ADDENDUM NO. 2

CONTRACT NO. 22-522

**Domestic Water System Improvements
Westchester County Airport
Town of Harrison, North Castle and Village of Rye Brook, New York**

1. CONCRETE TO TEST 4000 PSI @ 28 DAYS.
2. WELDED WIRE MESH ASTM-A-185.
3. 376 GALLON CAPACITY PER RING.
4. MANUFACTURED BY PRECAST CONCRETE SALES,
VALLEY COTTAGE, NY, OR APPROVED EQUAL

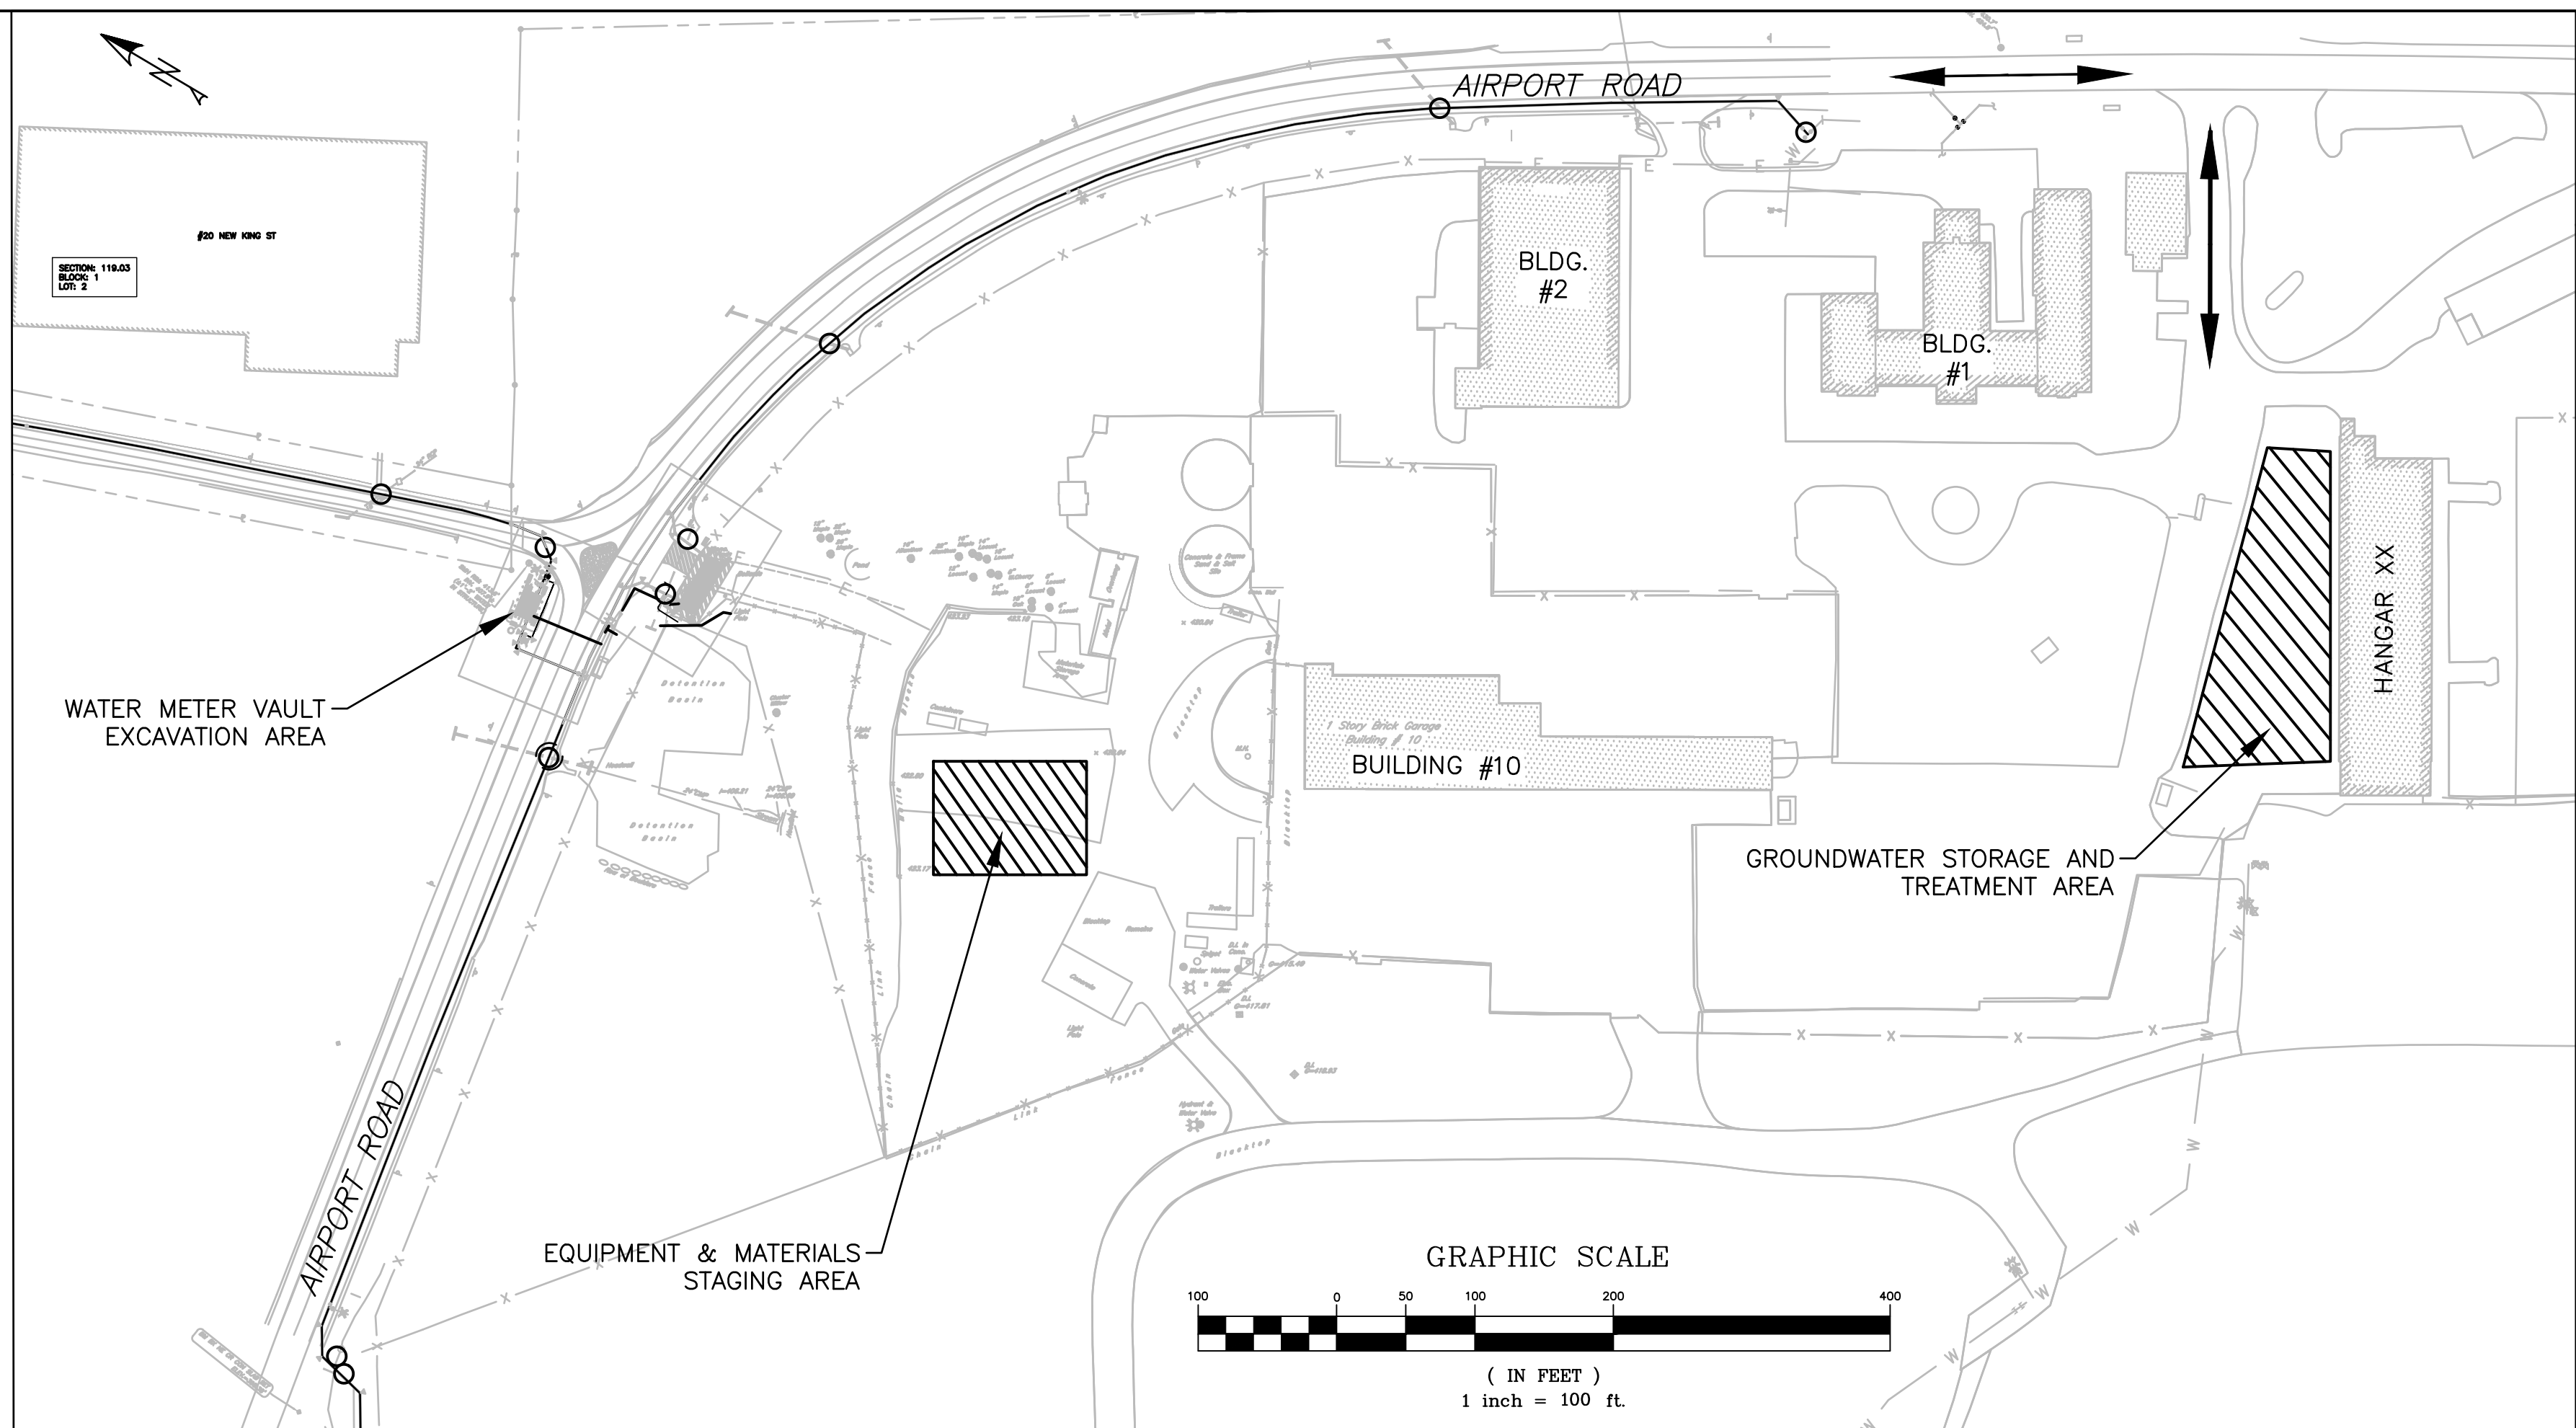
Item 4: Drawing C-29 shall be deleted and the revised drawing C-29 is attached hereto.

28	The technical spec appears to general in nature and not specific for this project. With regards to the buildings, please specify if coatings are required for: CMU block (interior and exterior), concrete slab, interior piping coating (paint & color). Also, are identification signs or tags needed?	<p>No interior or exterior coating of CMU is required. Interior concrete slab coating will be as specified in Section 03 30 00, paragraph 3.8.</p> <p>Aboveground plumbing piping shall be insulated per spec section 22 07 19 and labeled/identified per spec section 22 05 52. Piping is not required to be painted.</p>
29	Owners Protective Liability Policy naming the County as insured, with a minimum limit of liability per occurrence of \$3,000,000 (where applicable, or as determined by the Director, Risk Management - is an Owners Protective Liab policy required?	This policy is required.
30	Please confirm whether transportation of pumped groundwater from work area to proposed treatment area is included in pricing for item no. GG (groundwater treatment and disposal)	Refer to the notes on revised drawing C-29 included herein.

- GROUND WATER FROM DEWATERING OPERATIONS IS NOT PERMITTED TO BE DISCHARGED TO THE GROUND SURFACE, DRAINAGE DITCH, SURFACE WATER BODY, STREAM, WETLAND, STORM DRAIN OR SANITARY SEWER.

- THE CONTRACTOR SHALL FURNISH, INSTALL AND OPERATE A GROUNDWATER TREATMENT SYSTEM THAT WILL BE USED TO TREAT GROUNDWATER THAT IS REMOVED FROM THE GROUND BY DEWATERING FOR THE PURPOSE OF REMOVING PER- AND POLYFLUOROALKYL SUBSTANCES (PFAS). REFER TO BLOCK DIAGRAM AND EQUIPMENT LAYOUT PREPARED BY GROUND WATER TREATMENT & TECHNOLOGY, LLC (GWTT).

- ALL GROUNDWATER REMOVED FROM EXCAVATIONS, PITS AND WORK AREAS, MUST BE TRANSPORTED TO THE DESIGNATED TREATMENT AREA. FINAL LOCATION AND LAYOUT OF TEMPORARY TREATMENT SYSTEM SHALL BE CONFIRMED AND REVIEWED BY AIRPORT OPERATIONS AND ENGINEER PRIOR TO INSTALLATION.

- ONCE WATER HAS BEEN TREATED THE MAXIMUM RATE OF DISCHARGE FROM THE TREATMENT SYSTEM INTO THE SANITARY SEWER SYSTEM, WILL BE LIMITED TO 17 GALLONS PER MINUTE (GPM) IN ACCORDANCE WITH DEF PERMIT. THE CONTRACTOR SHALL PROVIDE A FLOW CONTROL VALVE, CONTROLLED FLOW ORIFICE DEVICE OR OTHER APPROVED MEANS TO ENSURE DISCHARGE DOES NOT EXCEED 17 GPM. THE CONTRACTOR SHALL BE RESPONSIBLE TO RECORD EFFLUENT FLOW METER DATA AND SUBMIT TO THE ENGINEER AND OWNER'S REPRESENTATIVE FOR RECORD TO ENSURE DISCHARGE RATE IS NOT EXCEEDED.

- THE CONTRACTOR SHALL SUBMIT A SEQUENCE OF OPERATION OF THE TREATMENT SYSTEM TO THE ENGINEER FOR REVIEW. THE SEQUENCE OF OPERATION SHALL BE SIMILAR TO THE FOLLOWING:

- THE INFLUENT WEIR TANK SHALL BE PROVIDED WITH CONSTANT TANK VOLUME MONITORING AND LEVEL CONTROLS AS A MINIMUM: LOW WATER ALARM, HIGH WATER ALARM
 - THE INFLUENT FRAC TANK SHALL BE PROVIDED WITH CONSTANT TANK VOLUME MONITORING AND LEVEL CONTROLS AS A MINIMUM: LOW WATER ALARM, HIGH WATER ALARM, TRANSFER PUMPS ON/OFF.

- IN THE EVENT THAT THE FRAC TANK WATER SUPPLY REACHES "TRANSFER PUMP ON" LEVEL, THE PUMP(S) SHALL BE ENERGIZED AND SHALL RUN CONTINUOUSLY THROUGH THE TREATMENT SYSTEM UNTIL THE "TRANSFER PUMPS OFF" LEVEL IS REACHED. AUTOMATIC VALVES AT THE INLET/OUTLET OF THE TANK SHALL OPEN/CLOSE AS REQUIRED.

- THE EFFLUENT TANK SHALL BE PROVIDED WITH CONSTANT TANK VOLUME MONITORING AND FIELD ADJUSTABLE LEVEL CONTROLS AS A MINIMUM: LOW WATER ALARM, HIGH WATER ALARM, 25% FULL, 50% FULL, 80% FULL

- IN THE EVENT THAT THE EFFLUENT FRAC TANK REACHES 80% FULL THE TRANSFER PUMPS SHALL BE DE-ENERGIZED AND THE EFFLUENT DISCHARGED AT 17 GPM MAXIMUM. THE CONTRACTOR SHALL DETERMINE THE FREQUENCY OF EFFLUENT DISCHARGE BASED ON DEWATERING FIELD CONDITIONS.

- ALL TANKS SHALL BE PROVIDED WITH EXTERIOR AUDIBLE ALARMS.
